5 November 2021

RESPONSE TO SUBMISSIONS PART 1 – SSD11869481 - UPGRADES TO NORTH SYDNEY PUBLIC SCHOOL

Figure 1 2pm Mid-Winter Shadow Diagram Extract (Source: Fulton Trotter)

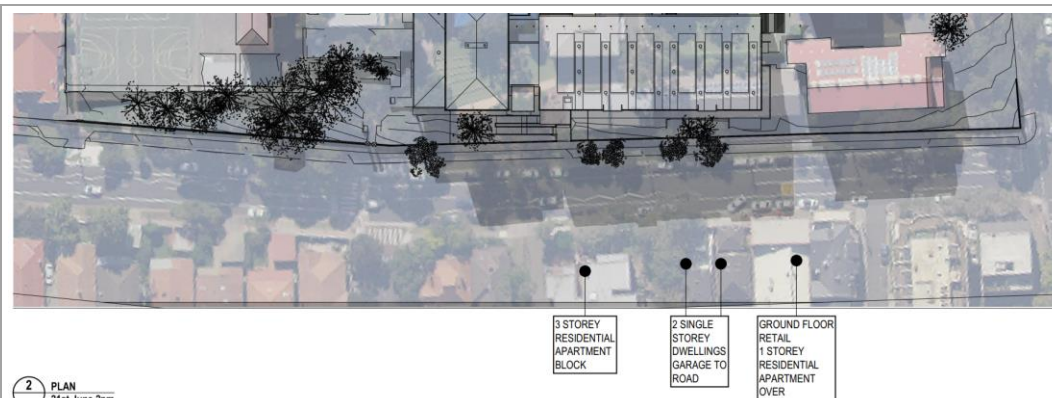
AGENCY	SUMMARY OF MATTERS RAISED	PROPONENT'S RESPONSE
	<p>construction worker parking does not detract significantly from existing on-street parking supply.</p>	
	<p>Built Form and Urban Design</p>	<p>A detailed response to DPIE and GANSW's built form and urban design feedback will be provided in part two of the RtS, following the SDRP meeting on 10 November 2021.</p>
	<p>Address the Government Architect NSW comments on the EIS dated 6 October 2021.</p>	
	<p>Shadowing</p> <p>Sections 7.3.2 and 7.1.2 of the EIS state that shadows generated by the proposal would not impact surrounding development and that shadows would fall onto Bay Road and the footpath at 3pm in mid-winter. The shadow diagrams lodged with the EIS show that at 3pm shadows are cast across Bay Road and onto properties opposite the site on Bay Road. To allow for proper assessment of shadow impacts, hourly shadow diagrams are required between 12pm and 3pm in mid-winter, and elevation shadow diagrams are required to demonstrate from what time and where shadows will fall on north facing elevations of development opposite the site on Bay Road.</p>	<p>Following discussion with DPIE on 22 October 2021, it was agreed that hourly plan shadow diagrams would be sufficient in demonstrating/assessing the shadow impact of the proposal, as opposed to requiring submission of elevational diagrams. To this end, Fulton Trotter has prepared hourly interval shadow diagrams for the mid-winter period and they can be found at Appendix 5. The shadow analysis clearly demonstrates the shadow cast from the proposal starts to encroach within the boundaries of a series of properties on the southern side of Bay Road at 2pm. These properties comprise a mix of single residential dwellings, to three (3) storey apartment buildings and a few mixed-use developments closer to the Pacific Highway (with retail at the ground floor and residential apartments above). However, as can be seen in the extracts below, which provide a snapshot of the shadow impact at 2pm and 3pm, there is very little impact at 2pm. The impact is more evident at 3pm.</p>

- At 2pm, there is overshadowing to Bay Road, the road reserve and what appears to be a very minor part of the front boundary of 12-14, 10, 10A (which is a battle-axe lot), 8B (which is also a battle-axe lot), 10 and 8A Bay Road. No dwellings or habitable areas are affected. A very minor shadow is cast to a very small part of the northern façade of the garages to 10 and 8A/8B Bay Road.
